**ADDENDUM  
NO. 1**

**March 17, 2025**

**PORTER LAKES ELEMENTARY SCHOOL  
ADDITION, RENOVATIONS, AND RELATED WORK  
Hebron, IN 46341**

This Addendum consists of Pages ADD 1-1, Specification Section 00 34 10 – Responsible Bidding Practices, and attached Addendum No. 1 from Gibraltar Design, Inc. dated March 14, 2025 and consisting of 6 pages, Specification Section 07 41 13 – Aluminum Roofing and 28 drawings.

**1 FOUNDATION PLAN - AREA D**  
1/8" = 1'-0"

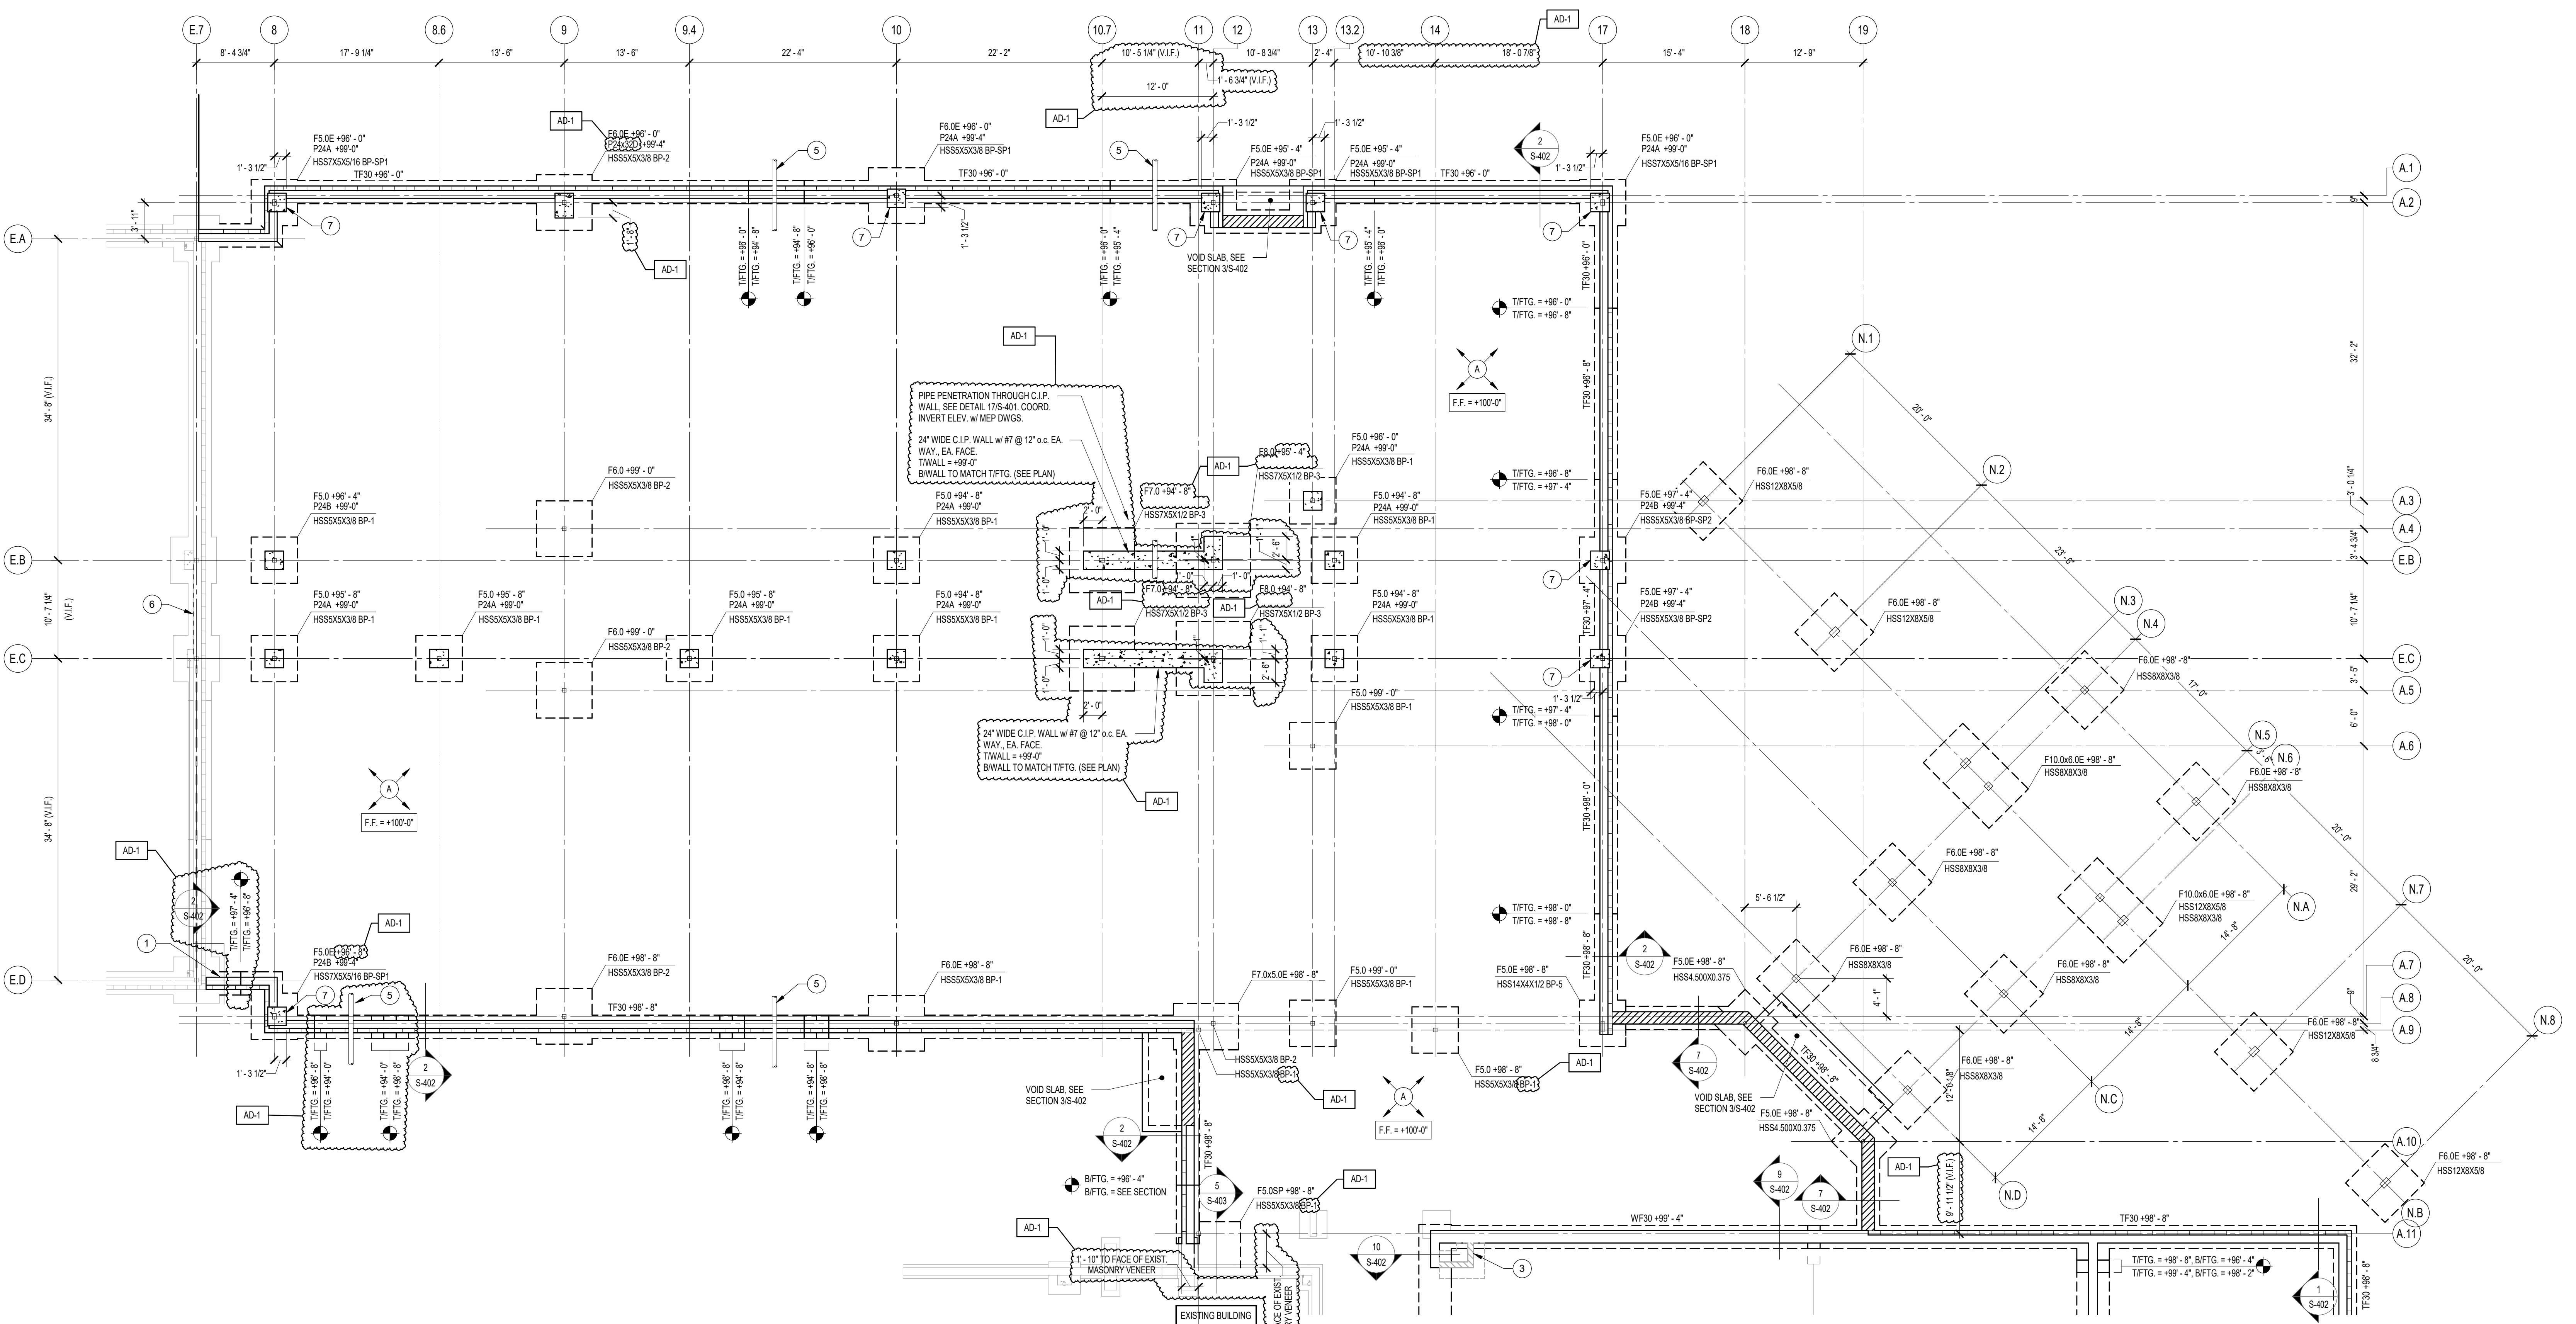
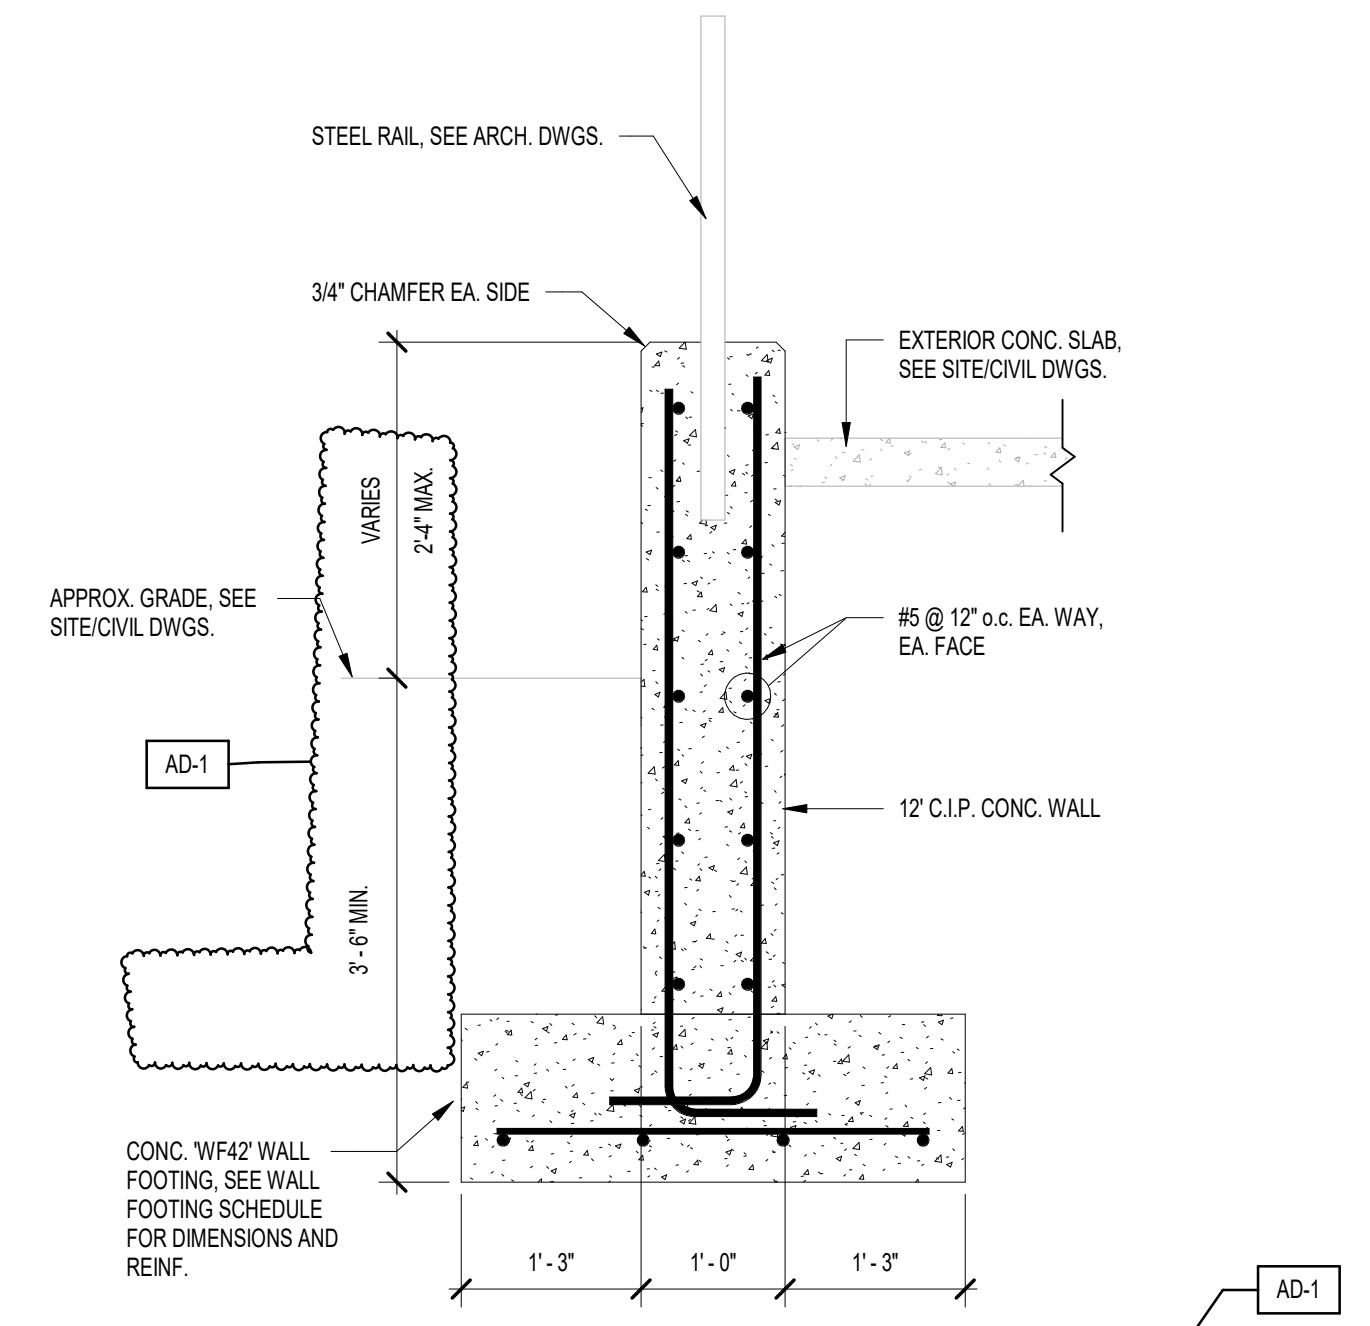
- A. Refer to revised, full-size drawing, included in this Addendum, for revisions.
  - 1. Pipe Penetration Shifted at the Southeast Corner of the Classroom Addition
  - 2. Stepped Footings Changed at the Southeast Corner of the Classroom Addition
  - 3. Subgrade Cast-In-Place Walls Added at Intersecting Corridors in the Classroom Addition
  - 4. Footings Sizes Changes and adjusted in Elevation
  - 5. Concrete Pier at Grids 9 & A.2 Changed
  - 6. Gridline 14 Shifted
  - 7. Verify in Field Dims. Between Gridlines Added
  - 8. Retaining Wall at Playground Section Modified

**1 ROOF FRAMING PLAN - AREA D**  
1/8" = 1'-0"

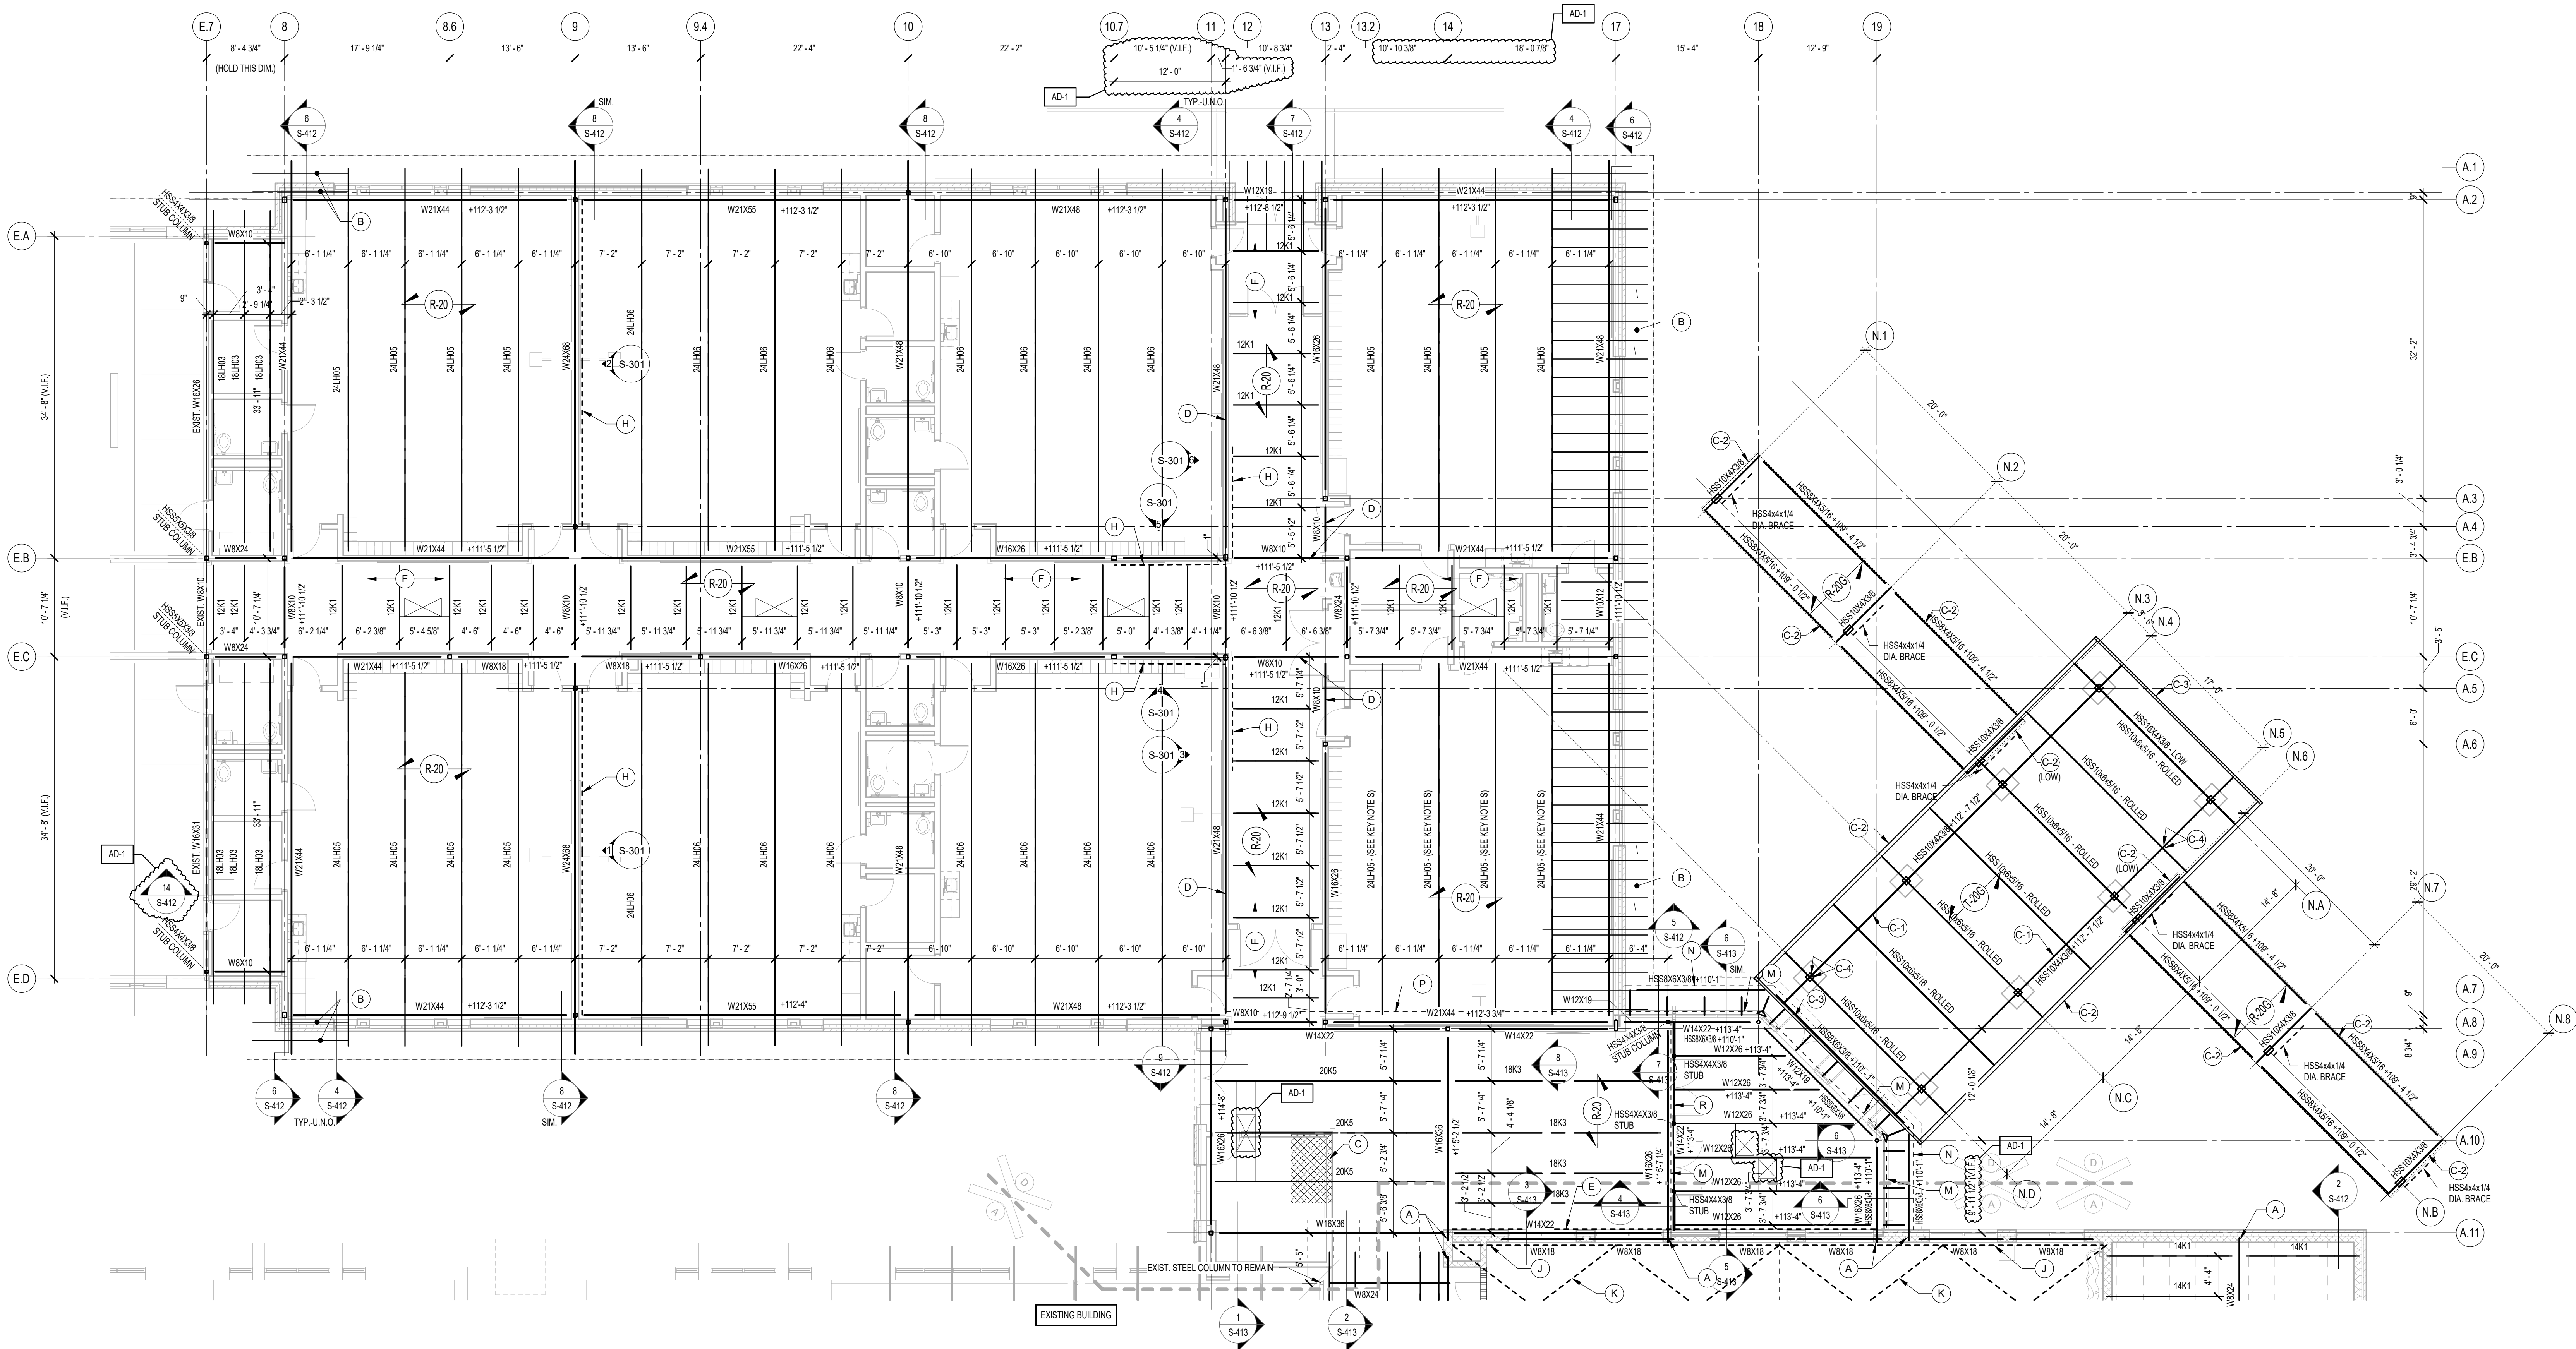
- A. Refer to revised, full-size drawing, included in this Addendum, for revisions.
  - 1. Section 14/S-412 Added
  - 2. Roof Drain Frames Added
  - 3. Verify in Field Dims. Between Gridlines Added
